SULLIVAN'S ADDITION TO BOWERS LANE **SUBDIVISION**

APPLICATION NUMBER 6 DATE August 6, 2009

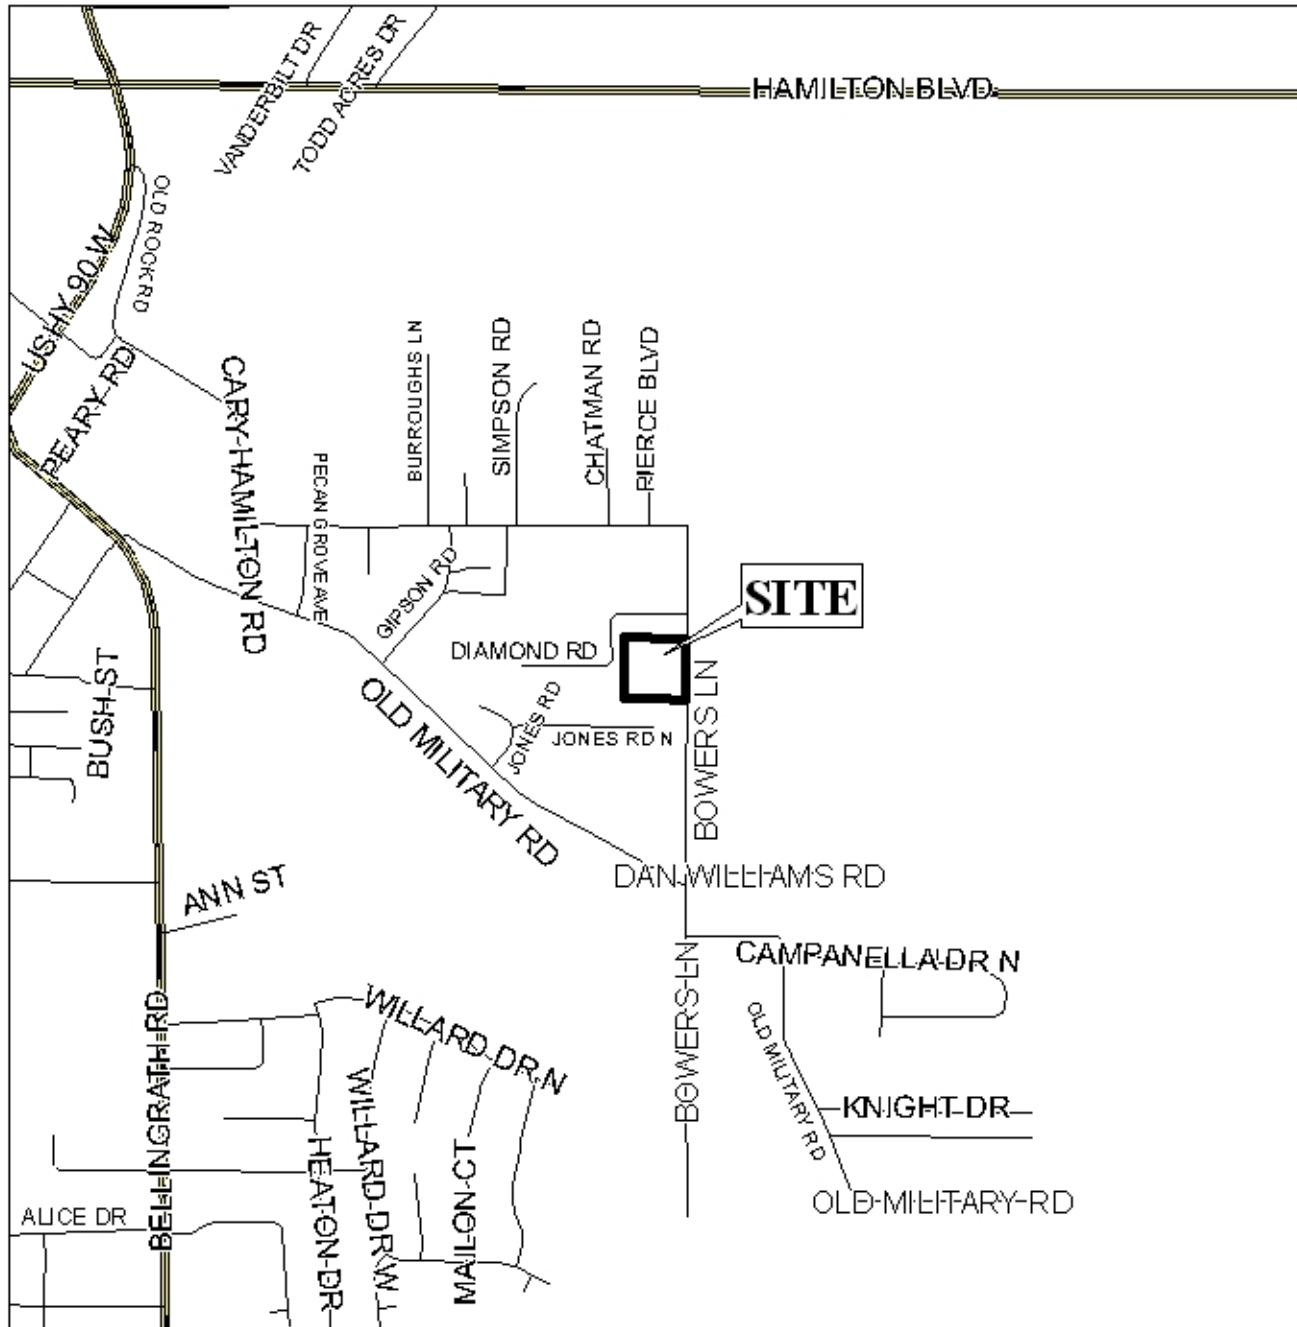
The site fronts Bowers Lane, a paved and publicly-maintained road with a compliant 50' right-of-way; therefore, no dedication would be required. As a means of access management, a note should be required on the final plat stating that Lots 1 and 3 are limited to one curb cut each, and Lot 2 is limited to two curb cuts, with the size, location, and design to be approved by Traffic Engineering and conform to AASHTO standards. As on the preliminary plat, the final plat should illustrate the 25' minimum building setback line. Also, as on the preliminary plat, each lot should be labeled with its size in acres and square feet, or a table should be furnished on the final plat providing the same information.

As proposed, the lots exceed the maximum depth-to-width ration of Section V.D.3. of the Subdivision Regulations; however, narrow, deep lots are typical within the surrounding area. Therefore, a waiver of Section V.D.3. would be in order.

- 1) placement of a note on the final plat stating that Lots 1 and 3 are limited to one curb cut each, and Lot 2 is limited to two curb cuts, with the size, location, and design to be approved by Traffic Engineering and conform to AASHTO standards;

- 2) illustration of the 25' minimum building setback line along Bowers Lane;
- 3) labeling of each lot with its size in square feet and acres, or the furnishing of a table on the final plat providing the same information;
